Re: Florida Power & Light Company
Proposed Turkey Point Units 6 and 7
Docket Nos. 52-040 and 52-041
Response to NRC Request for Additional Information Letter No. 58 (eRAI 6434) - Concerning Implementation of Fukushima Near-Term Task Force Recommendations

NRC RAI Letter No. PTN-RAI-LTR-058 Dated May 1, 2012

NRC RAI Number: 01.05-1 (eRAI 6434)

Figure 11: Contributions of Various Source Types to Hard Rock Hazard for 10 Hz

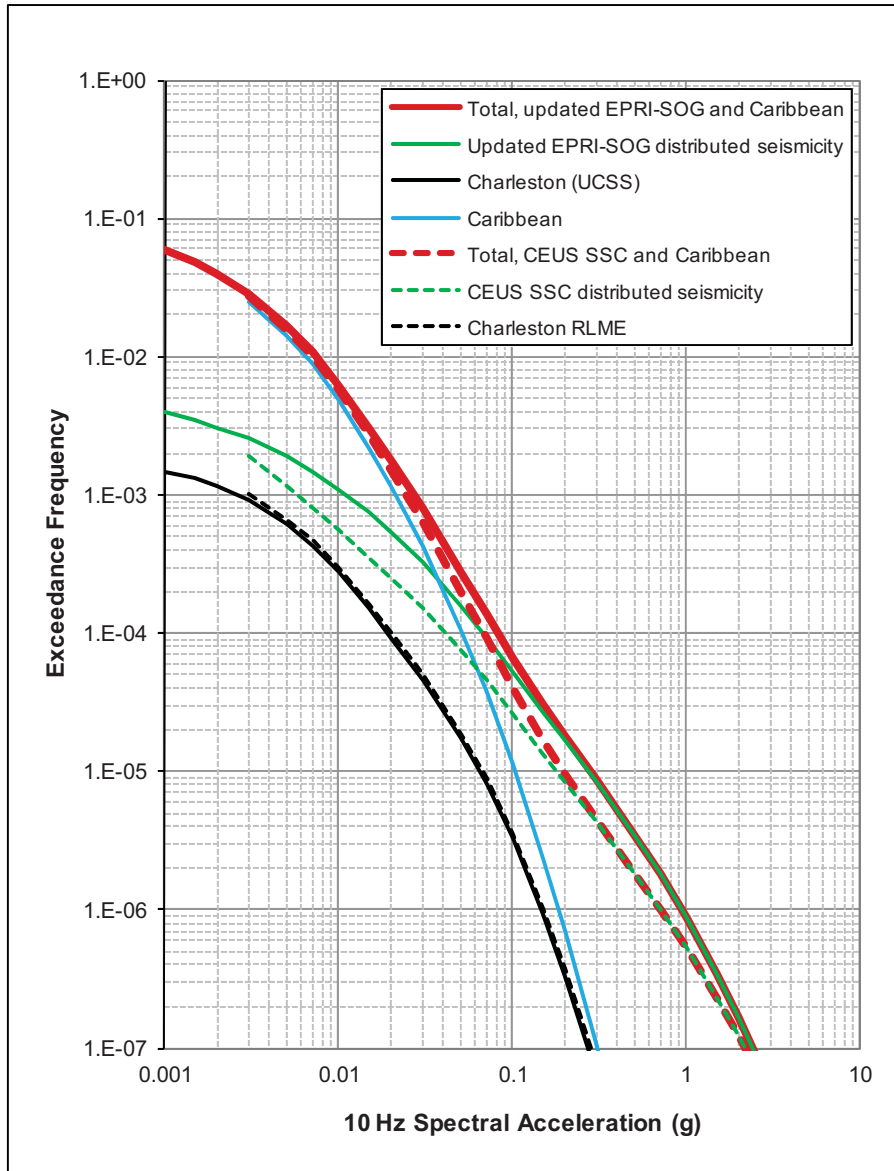
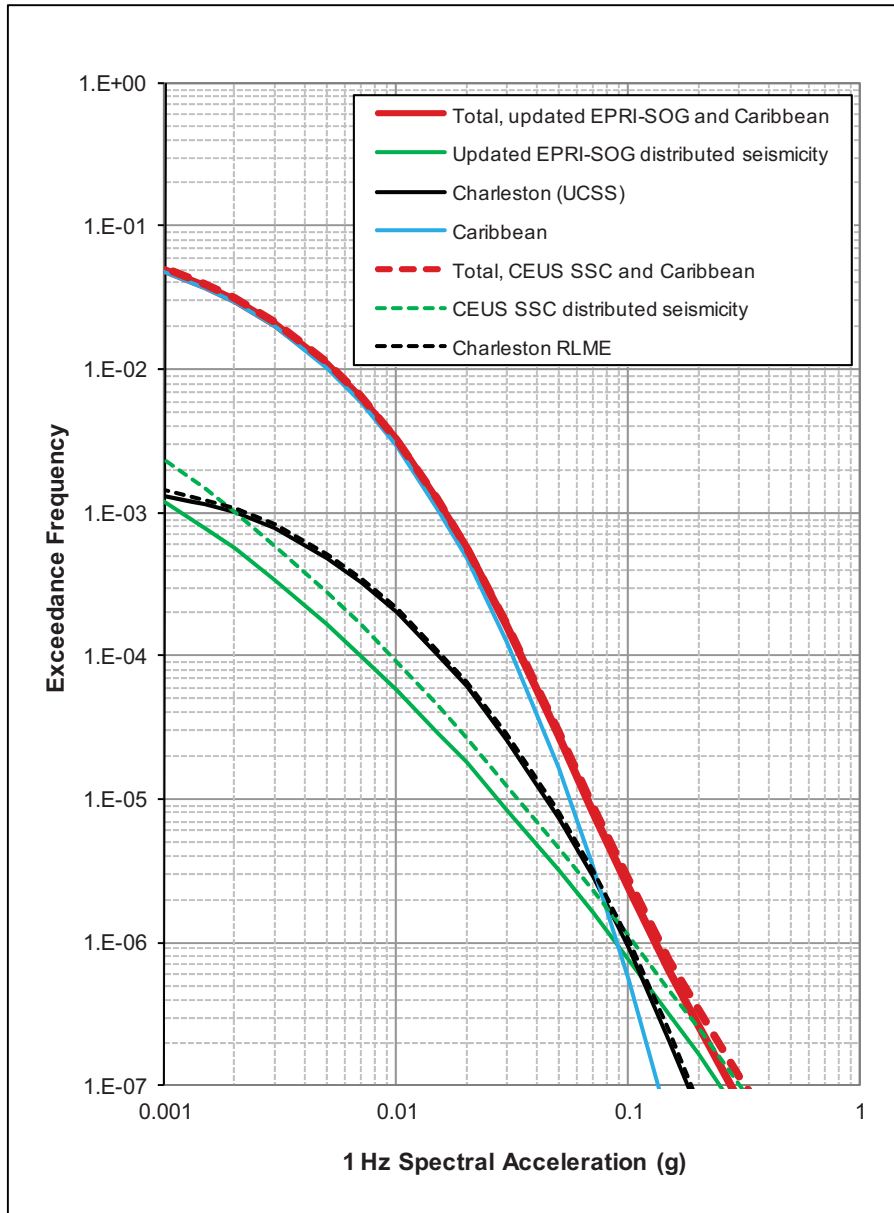
- a) Evaluate the potential impacts of the newly released CEUS SSC model, with potential local and regional refinements as identified in the CEUS SSC model, on the seismic hazard curves and the site-specific ground motion response spectra (GMRS)/foundation input response spectra (FIRS). For re-calculation of the PSHA, please follow either the cumulative absolute velocity (CAV) filter or minimum magnitude specifications outlined in Attachment 1 to Seismic Enclosure 1 of the March 12, 2012 letter "Request for information pursuant to Title 10 of the *Code of Federal Regulations* 50.54(f) regarding Recommendations 2.1, 2.3, and 9.3, of the near-term task force review of insights from the Fukushima Dai-Ichi accident." (ML12053A340).
- b) Modify the site-specific GMRS and FIRS if you determine changes are necessary given the evaluation performed in part a) above.

Figures 11 and 12 show the contribution of the various source types to the total mean hazard for 10 Hz and 1 Hz spectral acceleration, respectively. The solid curves show the total mean hazard for the combined updated EPRI-SOG plus Caribbean sources and the mean hazard from the three major source types: the EPRI-SOG distributed seismicity sources, the Charleston (UCSS) source, and the Caribbean sources. The dashed curves show the total hazard for the combined CEUS SSC plus Caribbean sources and the mean hazard from the CEUS SSC distributed seismicity sources and the Charleston RLME source (the hazard from the Caribbean sources is the same for the two analyses). These results show that the hazard from the Charleston RLME is essentially the same as that from the Charleston USCC source. Thus, the differences in hazard between the updated EPRI-SOG model and the CEUS SSC model are due to differences in the characterization of the distributed seismicity sources within the CEUS. For 10 Hz spectral acceleration, the lower hazard produced by the CEUS SSC model is due to predicted lower frequency of earthquakes in the site region by this model as compared to that predicted by the updated EPRI-SOG model. For 1 Hz spectral acceleration, the CEUS SSC model distributed seismicity sources produce higher hazard than the updated EPRI-SOG distributed seismicity sources. This larger hazard for low frequency motions is likely due to the fact that the maximum magnitudes for the CEUS SSC distributed seismicity sources are generally larger than those for the updated EPRI-SOG seismic sources.

Figure 2.5.2-280 Seismotectonic Source Zones in the CEUS SSC Model

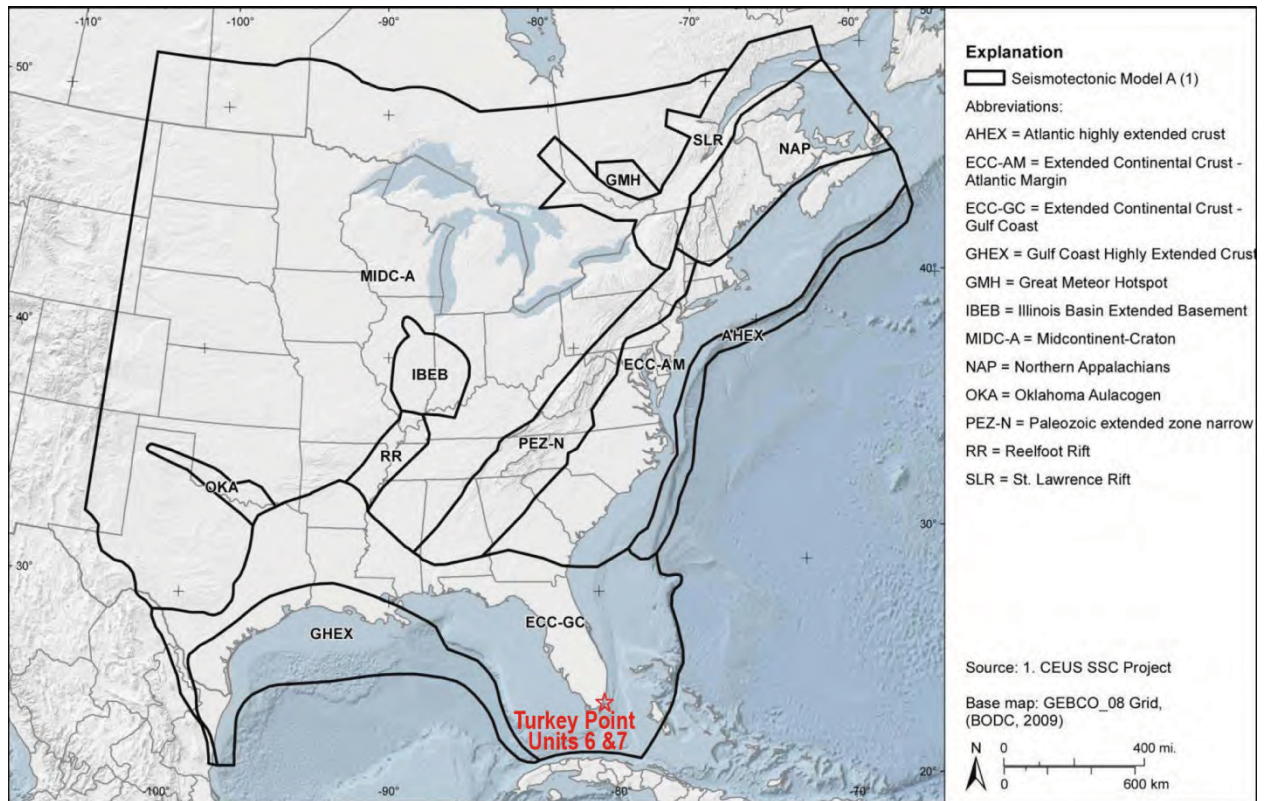
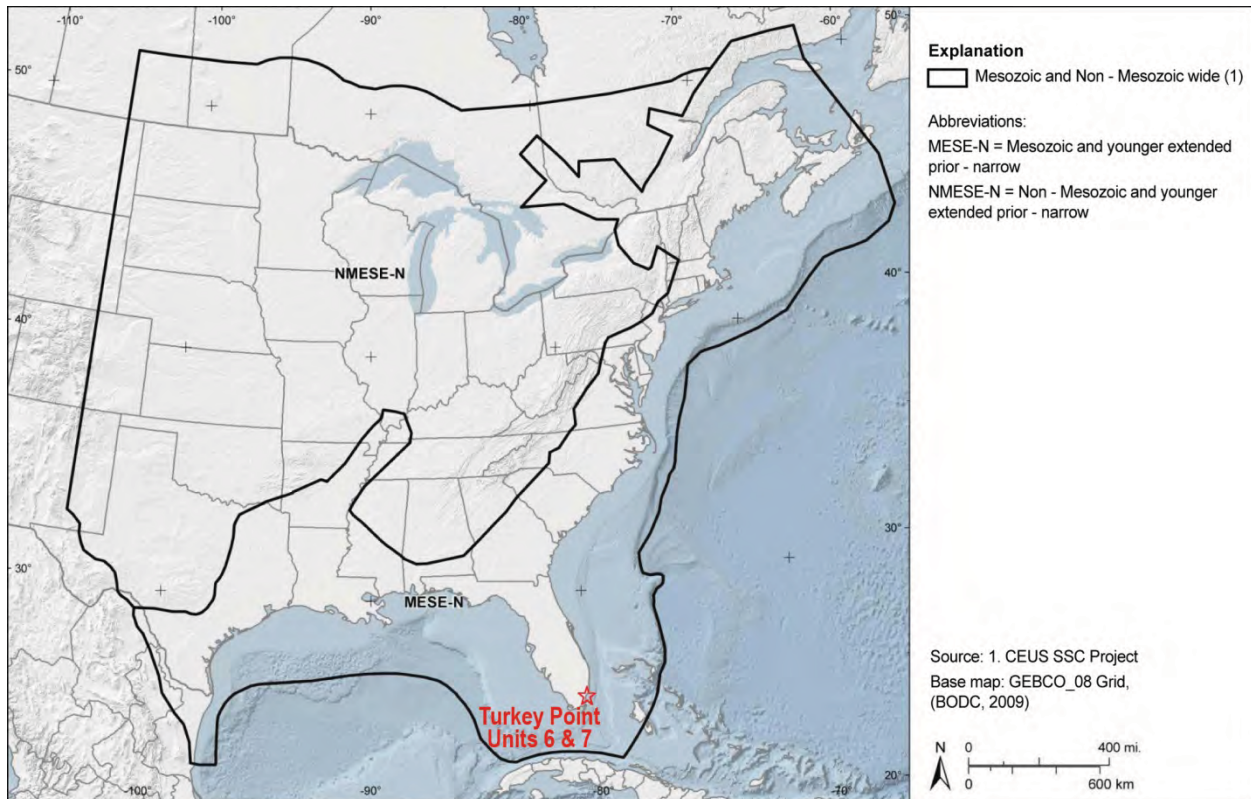
The following new Subsection 2.5.2.4.7 will be added to the COLA.

This section summarizes the CEUS SSC model. Details are provided in NUREG-2115 (Reference 353). The model for seismic sources in the CEUS consists of two types of seismic sources. The first type is seismic source zones used to model future distributed seismicity throughout the CEUS. As shown on Figures 2.5.2-280 and 2.5.2-281, two approaches are used to define the distributed seismicity sources. The seismotectonic approach (Figure 2.5.2-280) subdivides the CEUS into different source zones on the basis of differences in geology and tectonic history. The M_{\max} Zones approach (Figure 2.5.2-280) subdivides the CEUS into regions that are expected to have different values of the maximum magnitude that can occur. The second type of seismic source is used to model

Comparison of the areal extent of the CEUS SSC model shown on Figures 2.5.2-280 and 2.5.2-281 with the region encompassed by the updated EPRI-SOG seismic sources shown on Figures 2.5.2-204 through 2.5.2-209 indicates that the two source models cover the same region. In addition, Charleston RLME source in the CEUS SSC model, shown on Figure 2.5.2-282 occupies the same general location as the UCSS shown on Figure 2.5.2-212. Thus, the CEUS SSC model can be considered as a replacement for the updated EPRI-SOG model, including the UCSS source and the supplemental sources between Florida and Cuba in their entirety. As a consequence, an assessment of the effect of the CEUS SSC model on the total hazard for the site can be evaluated by subtracting from the total mean hazard presented in Subsection 2.5.2.4.6 and Table 2.5.2-223 the contributions of the updated EPRI-SOG sources and then adding the hazard contributed by the CEUS SSC model sources. Comparing the resulting values against the total hazard listed in Table 2.5.2-223 shows the sensitivity of the site rock hazard to use of the CEUS SSC model sources in place of the updated EPRI-SOG sources.
